TO: Planning and Zoning Commission
DATE: March 26, 2024
APPLICANT: Chris Beardon; *Wades Landing, LLC*
CASE NUMBER: SP2024-017; *Amended Site Plan for Wade's Landing at 308 Fannin Street*

PROJECT NUMBER: SP2024-017
PROJECT NAME: Amended Site Plan for 308 N. Fannin Street
SITE ADDRESS/LOCATIONS: 308 N FANNIN ST, ROCKWALL, 75087
CASE CAPTION:

SP2024-017: Amended Site Plan for an Existing Restaurant at 308 N. Fannin Street

SCALE: 1/4" = 1'-0"

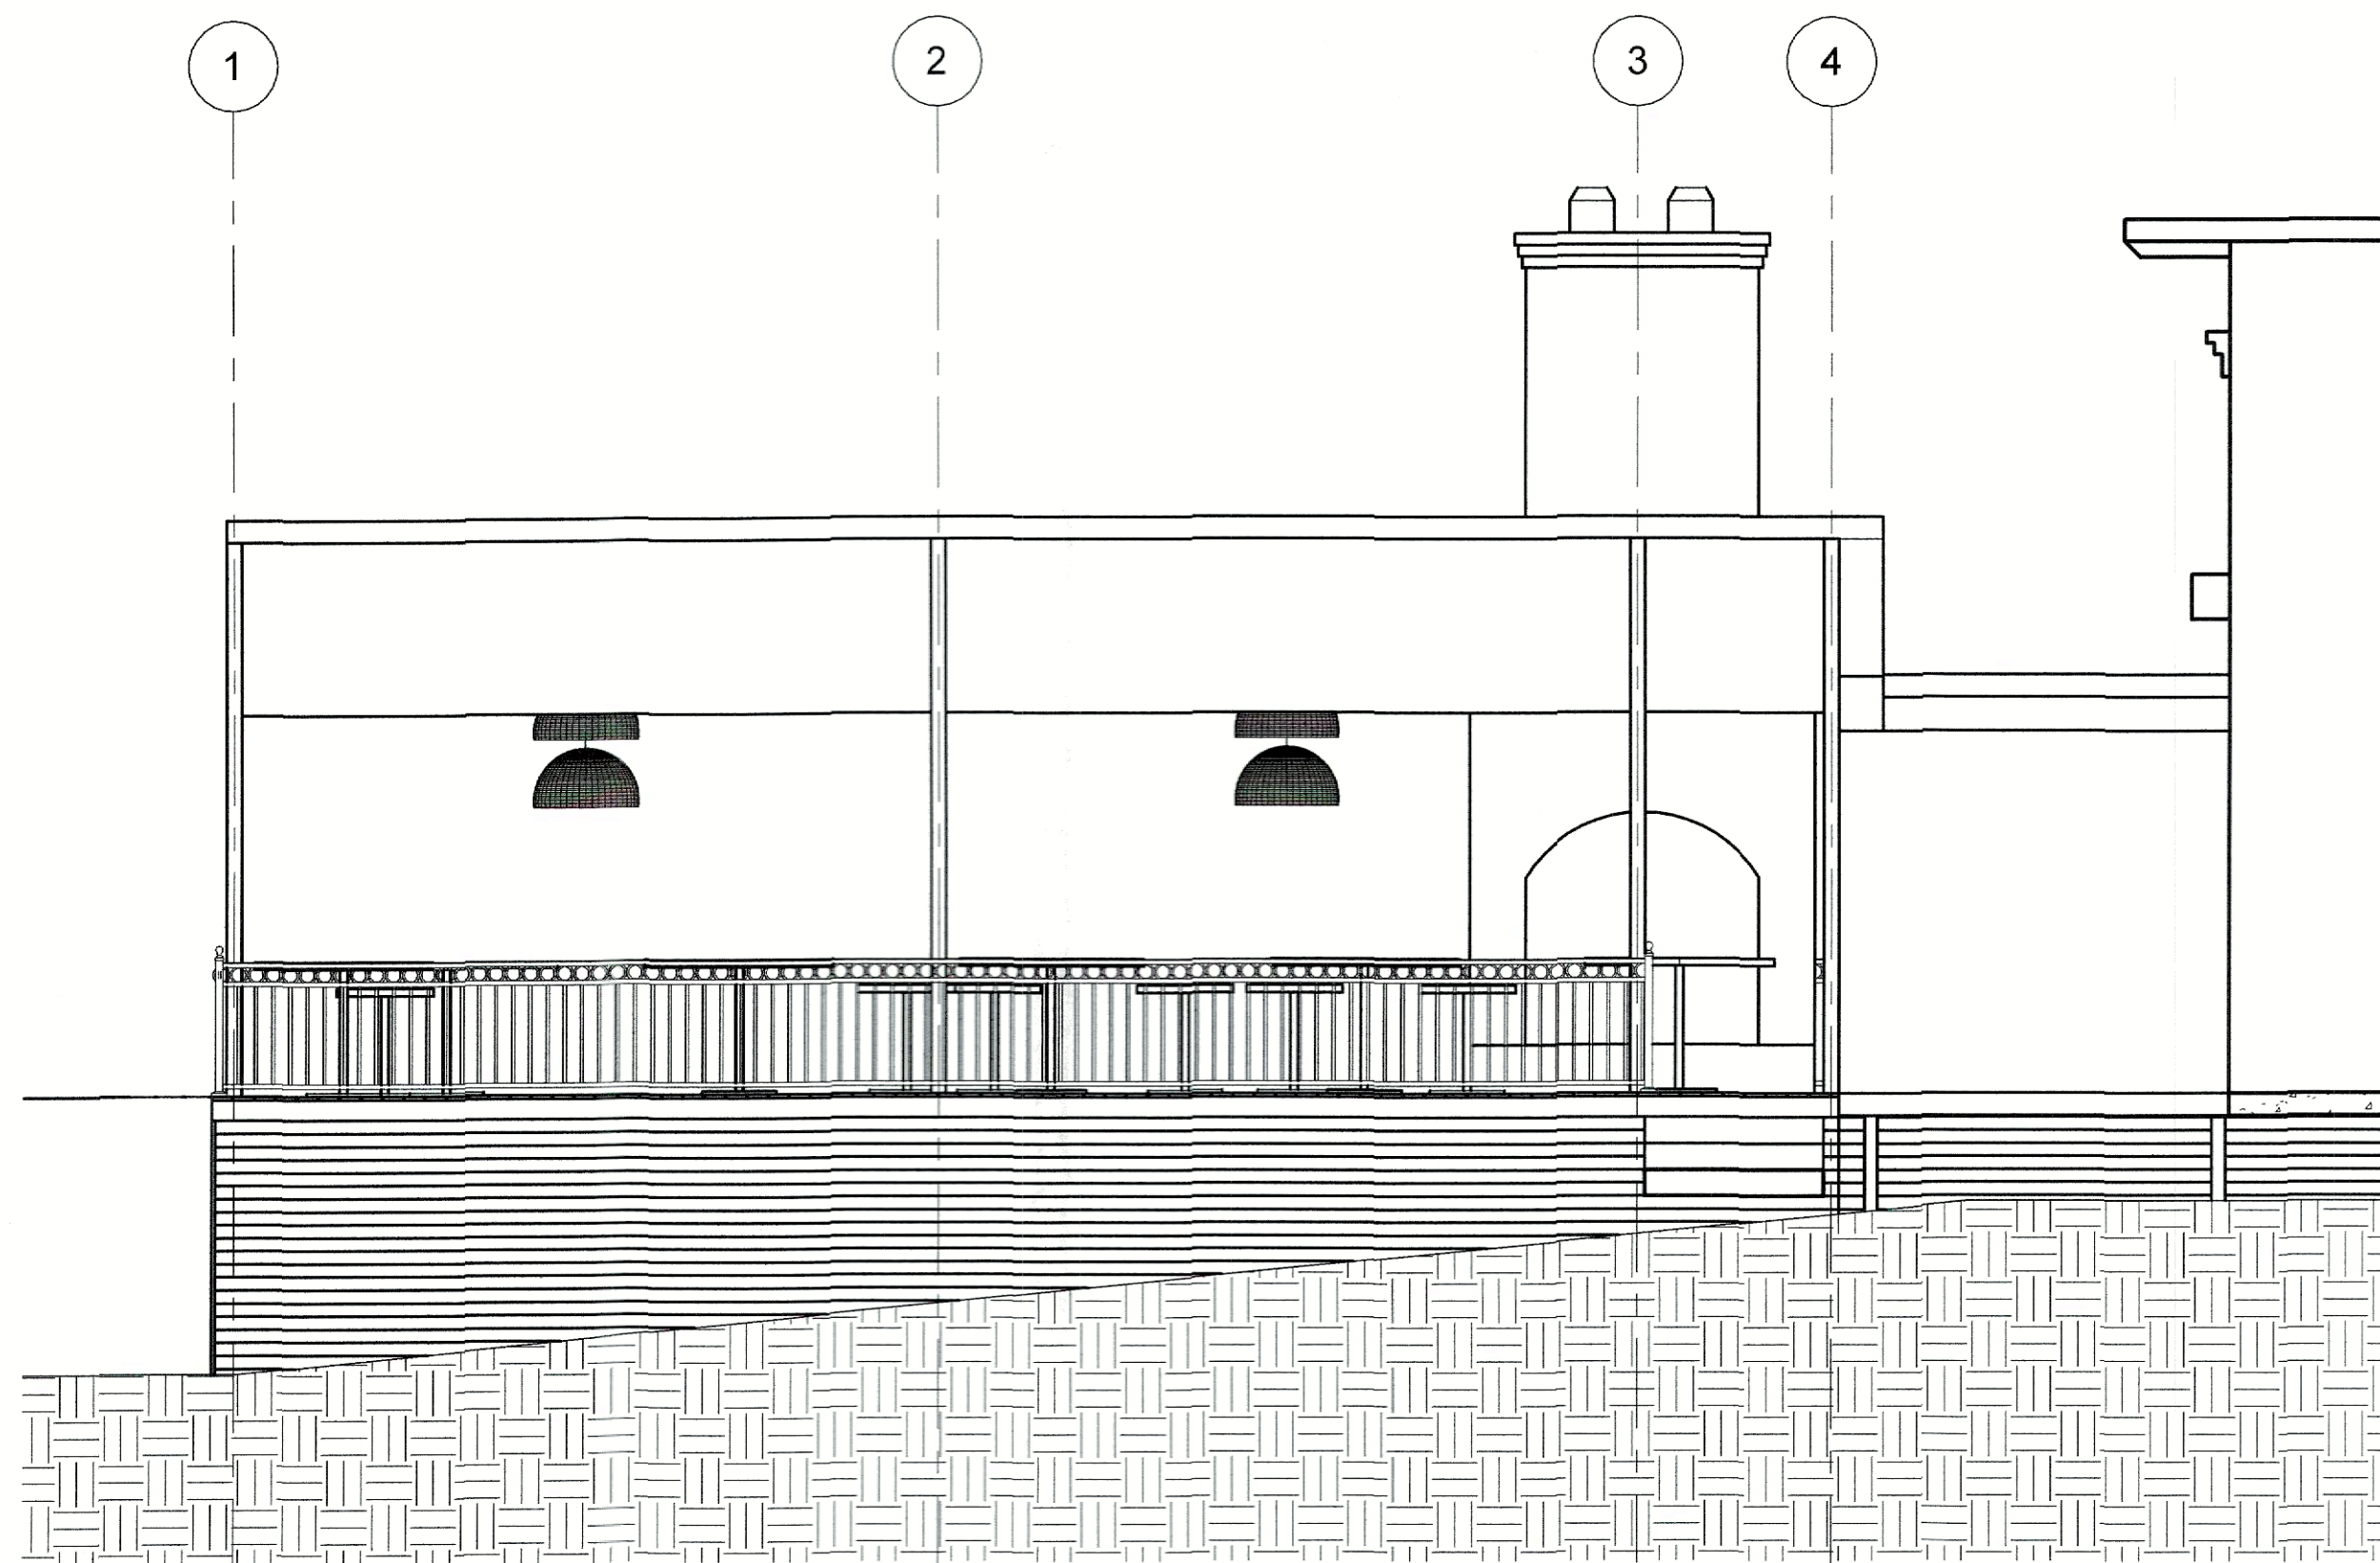
M.6 Building Elevations:

(1) If the roof is to be metal then it must be standing seam metal panels. In addition, the standing seam panels that extend down from the roof will require a Minor Waiver from the Planning and Zoning Commission. "Unpainted metal, or metal subject to ordinary rusting shall not be used as a building material. Factory finished metal elements as well as metals that develop an attractive oxidized finish, such as copper, galvanized metal, stainless steel or weathering steel, may be used as architectural accents by minor waiver approval." (Subsection 04.07. D. 2. C. 4, of Article 05, UDC)

Drawn by:
 J. PENTON
 Date:
 1/30/2024
 Scale:
 N.T.S.
 Sheet Title:
 Site Photometrics
 Sheet No:

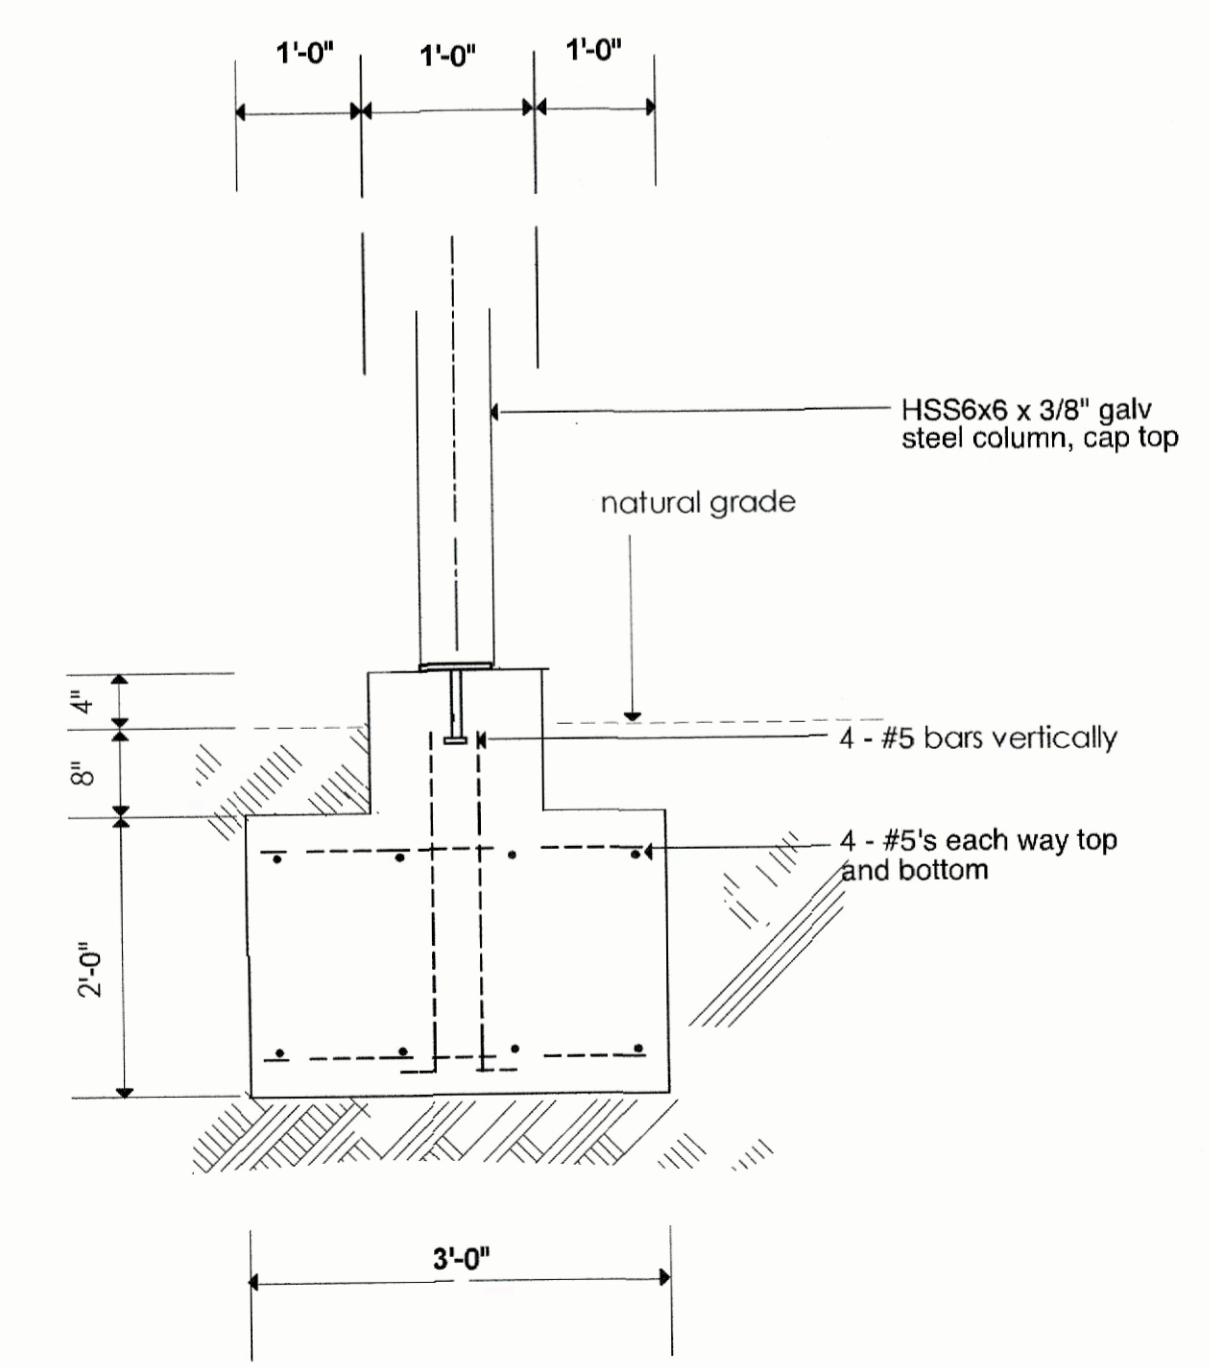
M.5 Photometric Plan:

(1) The light levels cannot exceed 20 FC. (Subsection 03.03. G, of Article 07)

(2) The light levels at the property line cannot exceed 0.2 FC. In this case, the southeast property line exceeds this amount. In addition, please include the north property line on the photometric. Given that lighting is changing on the north side of the building staff wants to ensure the 0.2 FC requirement is met. (Subsection 03.03. G, of Article 07)

(3) Please provide the proposed light fixtures. (Subsection 03.03. G, of Article 07)

(4) Please make note of the following requirement per the Downtown (DT) District zoning; "(a)ll lighting shall be focused downward or narrowly focused on its intended target such

as signing, parking and pedestrian walkways. No lighting source from a commercial activity shall be visible by a residential unit." (Subsection 04.07. E. 2. C, of Article 05, UDC)
